- Access to OBD information
- Information required for the manufacture of diagnostic tools

Revision 1 of Japan proposal: 2014/10/27

# Japan Concept

## **Article4.2.3** [Amendment proposal 2]

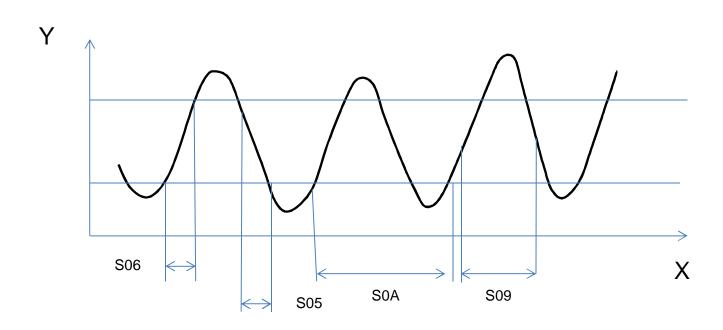
### The following are OBDII requirements

\$05 : Request oxygen sensor monitoring test results

\$06: Request on-board monitoring test results for

specific monitored (e.g. catalyst system)

Example for where each data is monitored Judge the deterioration by monitoring the signal variation

Delete texts below,

"In particular, a comprehensive explanation for the data in service \$ 05 Test

- -ID \$ 21 to FF and the data in service \$ 06 shall be provided. In the case of
- -vehicle types that use a communication link in accordance with ISO
- 15765-4 Road vehicles · Diagnostics on Controller Area Network (CAN)
- Part 4: Requirements for emissions-related systemsq a comprehensive
- explanation for the data in service \$ 06 Test ID \$ 00 to FF, for each OBD
- monitor ID supported, shall be provided."
